## LP1 LAUREL HILL COMMUNITY PLANNING SECTOR

11/15/2005: **Draft** revisions to LP1 reflect the Laurel Hill Adaptive Reuse Citizen's Task Force recommendations, updated factual information, and BOS actions such as the Park designations (i.e. Policy Plan Amendment No, 2003 P-07, adopted June 20, 2005).

**FIGURE 8**

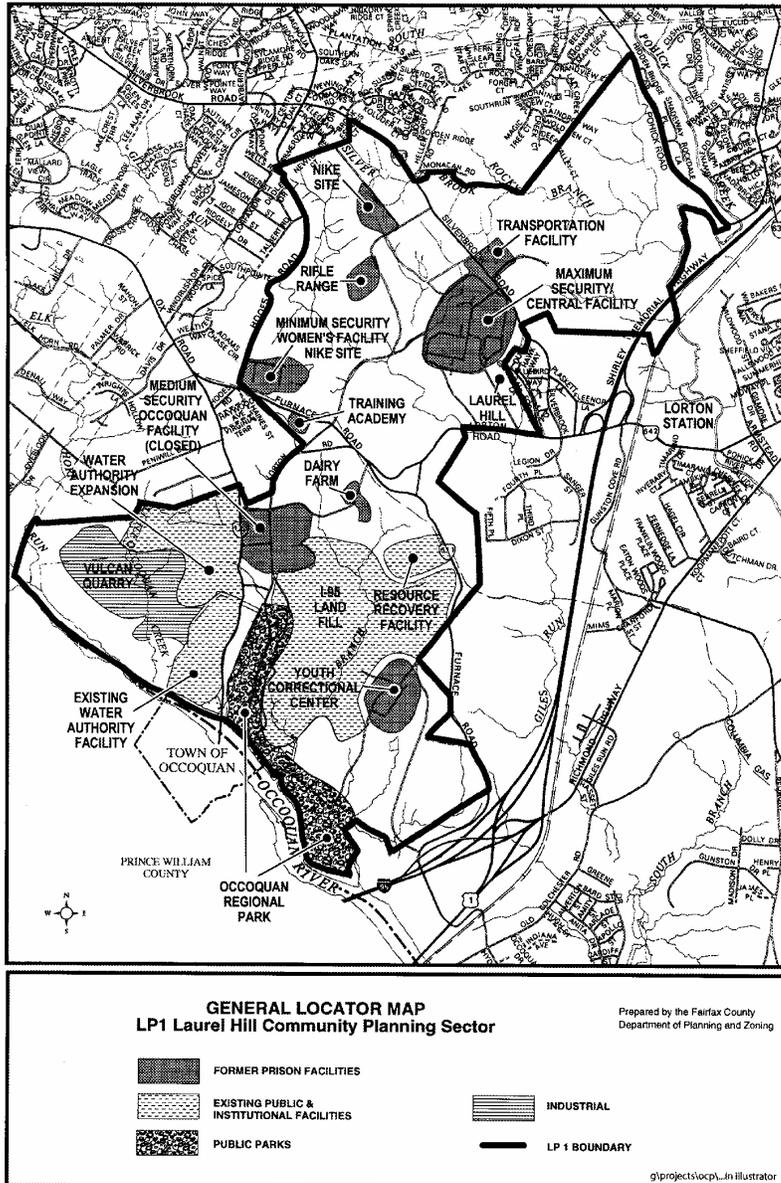
Modify Figure 8 as follows:

Change Title to: Location of Former Prison Facility Sites; Existing Public and Industrial Uses;

Modify: Laurel Hill house; Existing Fairfax Water Authority Facility; Water Authority Expansion; Note: Show entire area as Fairfax Water  
 Medium Security Occoquan Facility (closed); Add: High School; Add: Golf Course  
 Add: FCPA property under public parks

**FIGURE 9**

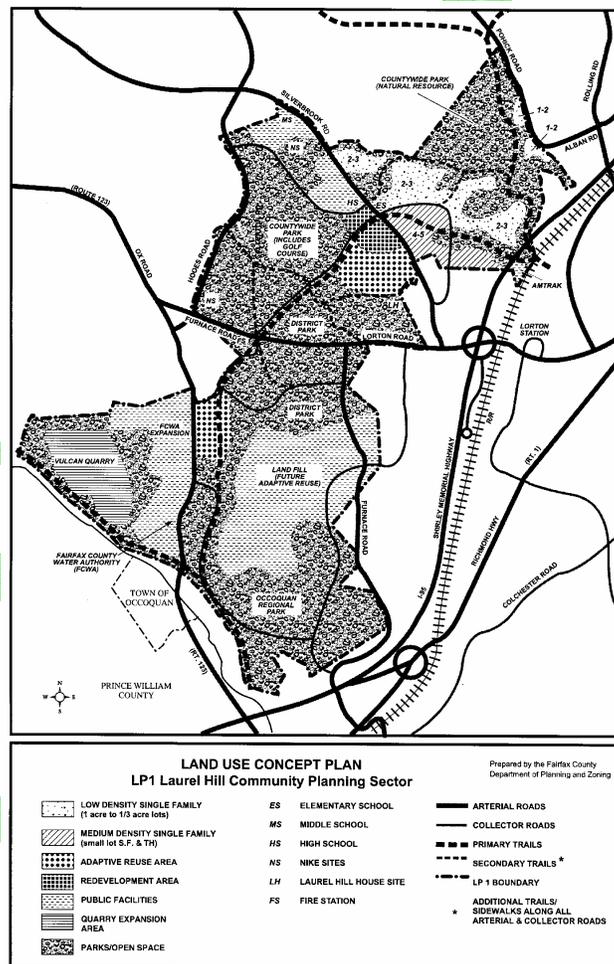
Figure 9: Delete: FCWA Expansion  
 Modify: Area where former Youth Center was needs to read for “Public Park”  
 Modify: Change park designations: Community to Local Park, Natural Resource to Resource-based Park; Modify: delineation of “Occoquan Regional Park”  
 Modify: Correct road alignments per approved HS and golf course plans.

**FIGURE 11**

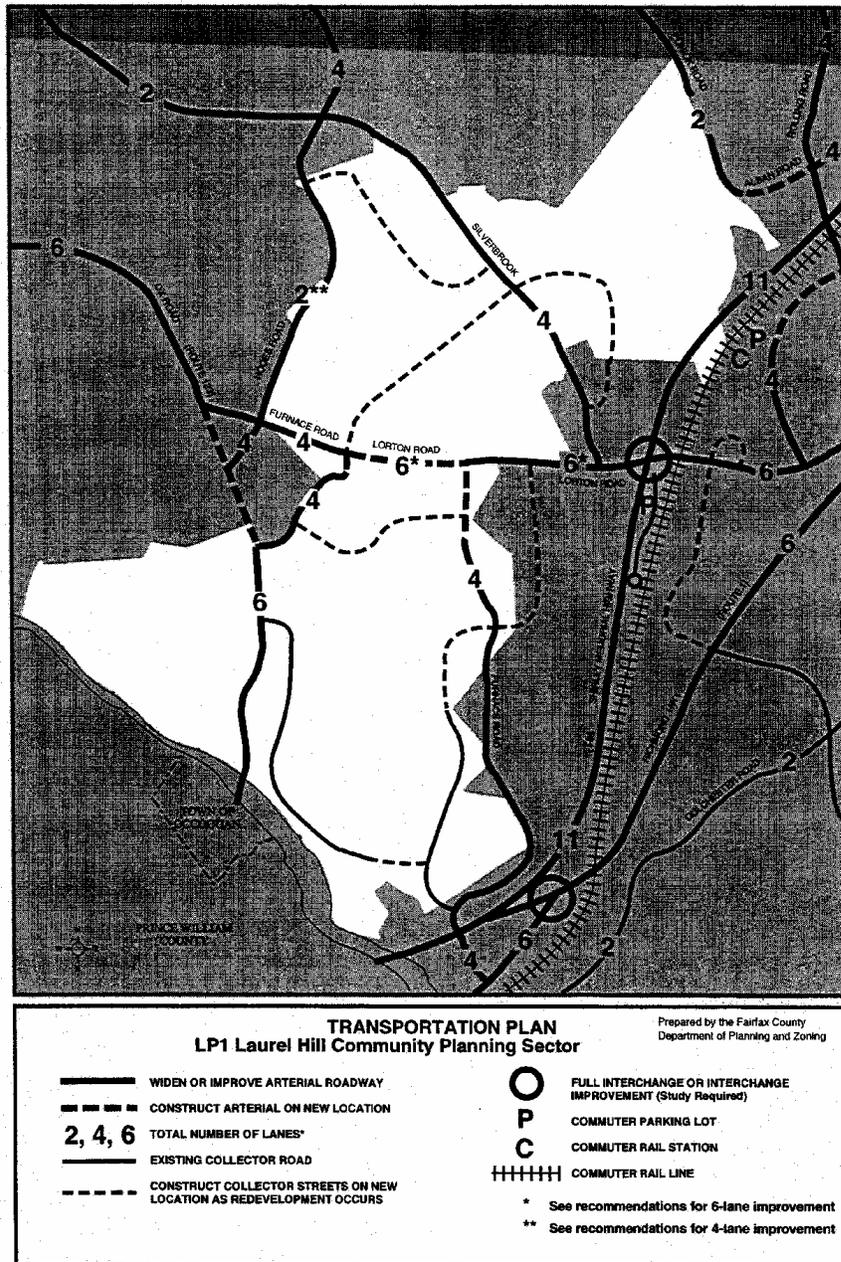
Figure 11: Modify: Label all roads, makes sure labels are visible.  
 Correct the alignment per golf course and HS plans. (Check all figures)

Figure12: Delete: ~~FCWA Expansion~~

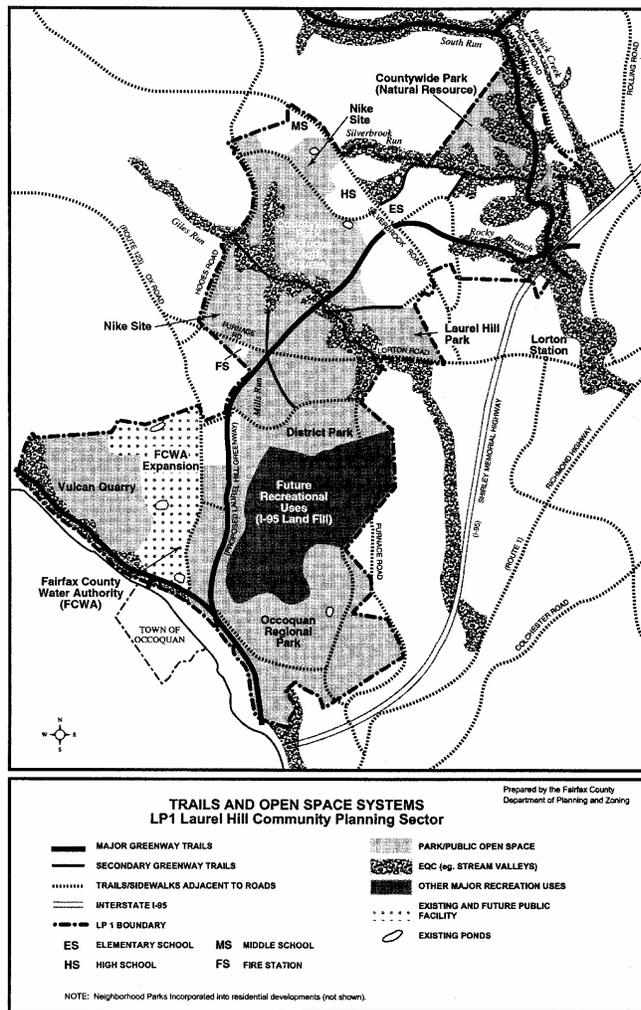
Modify: Area where former Youth Center was needs to read for “Public Park”

Modify: Change park designations: Community to Local Park, Natural Resource to Resource-based Park; Label for Countywide Park with Golf Course is not showing up

Modify: Locate trails based on adopted Parks Master Plan

**NOTE: CHANGE COUNTYWIDE TRAILS PLAN**

**FIGURE 16**

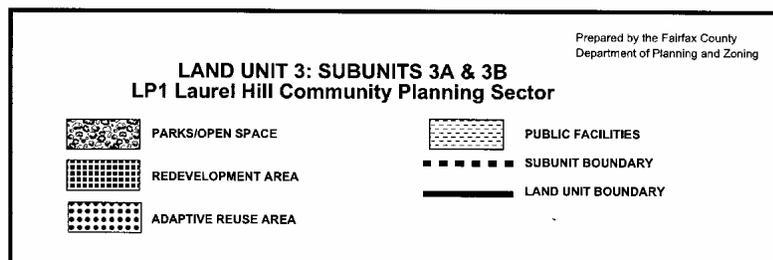
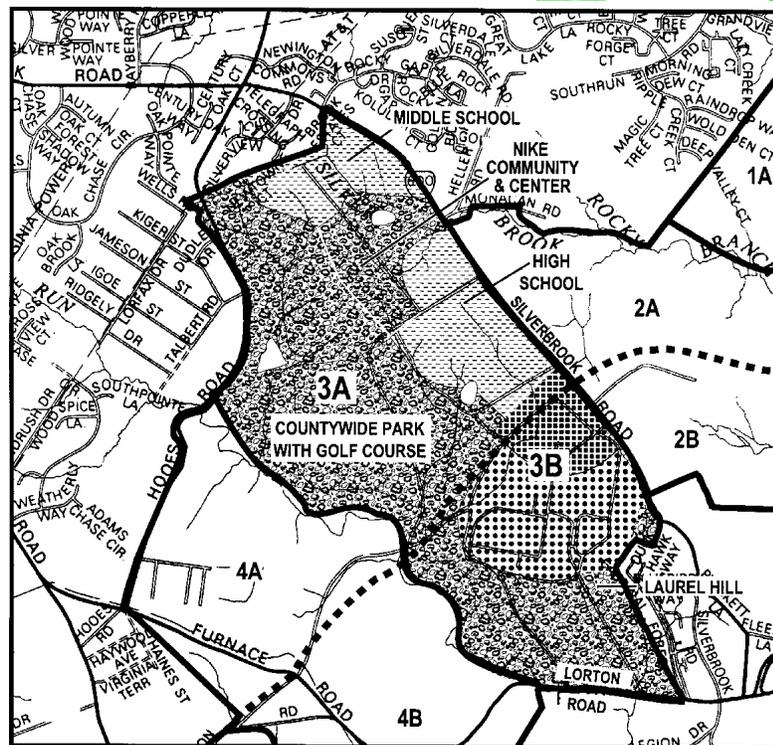
Modify: **Change park designations: Community to Local Park**  
 Modify: **Correct road alignments per approved HS and golf course plans.**

**FIGURE 22 17**

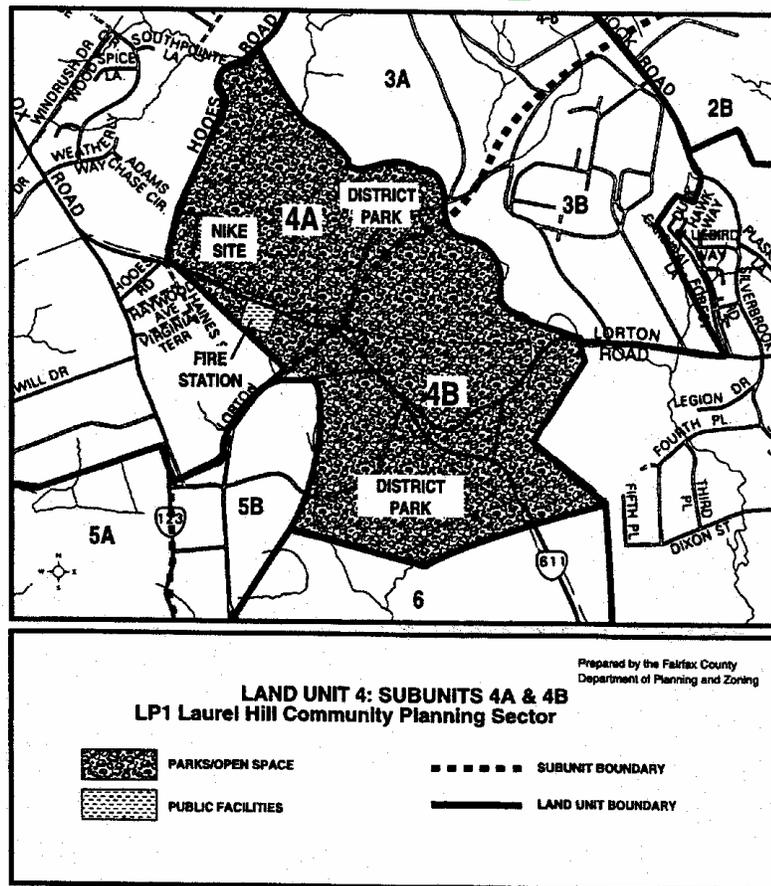
ADD: Dairy Farm

FIGURE 23 18

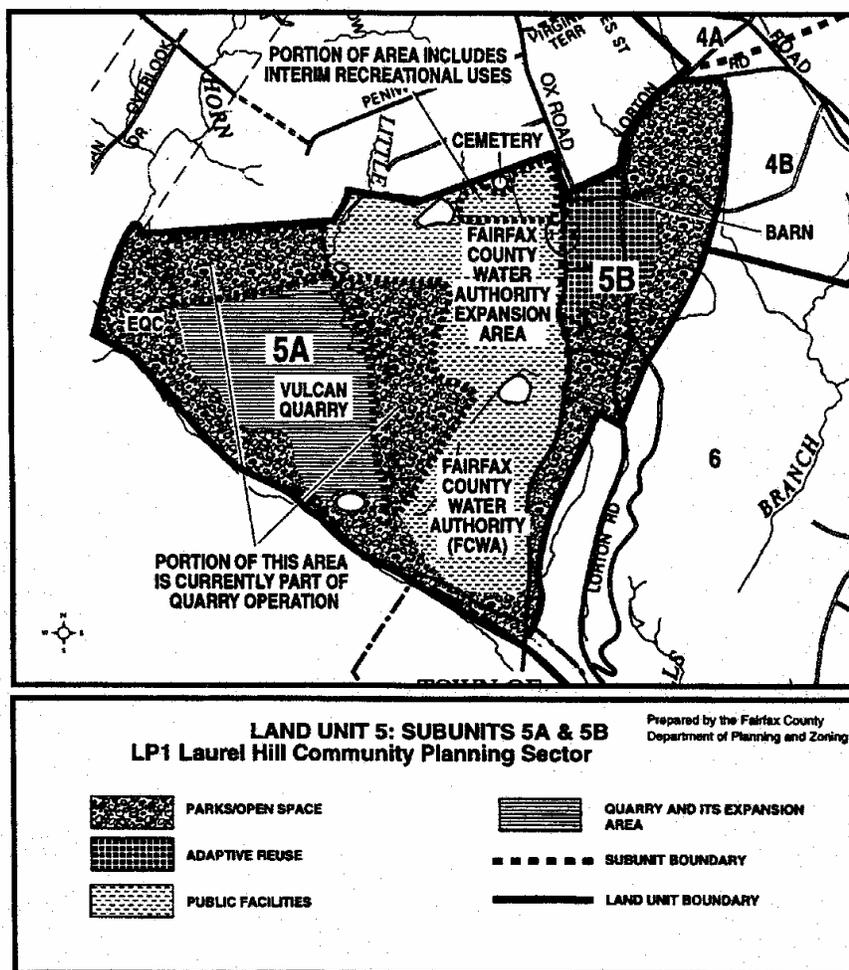
Delete: the words "Expansion area" Rename – Fairfax Water

FIGURE 24 19

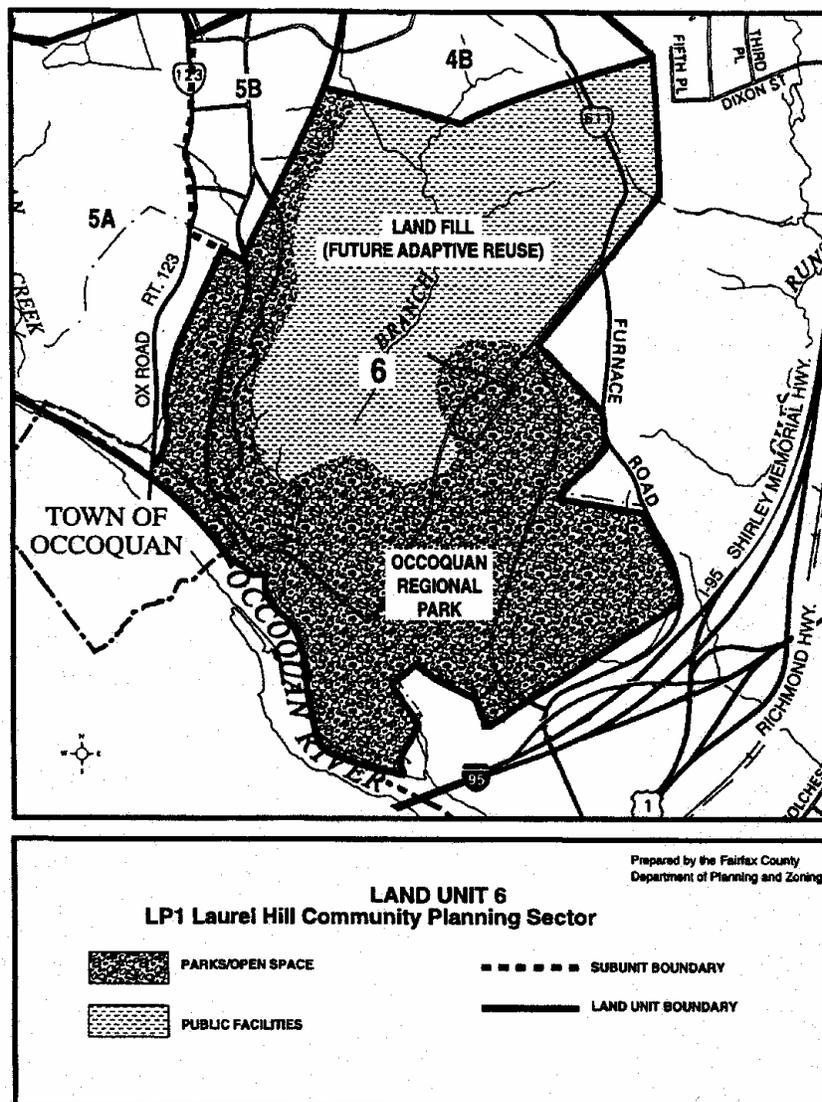
Show FCPA expansion to include youth center; Label FCP – Laurel Hill Park
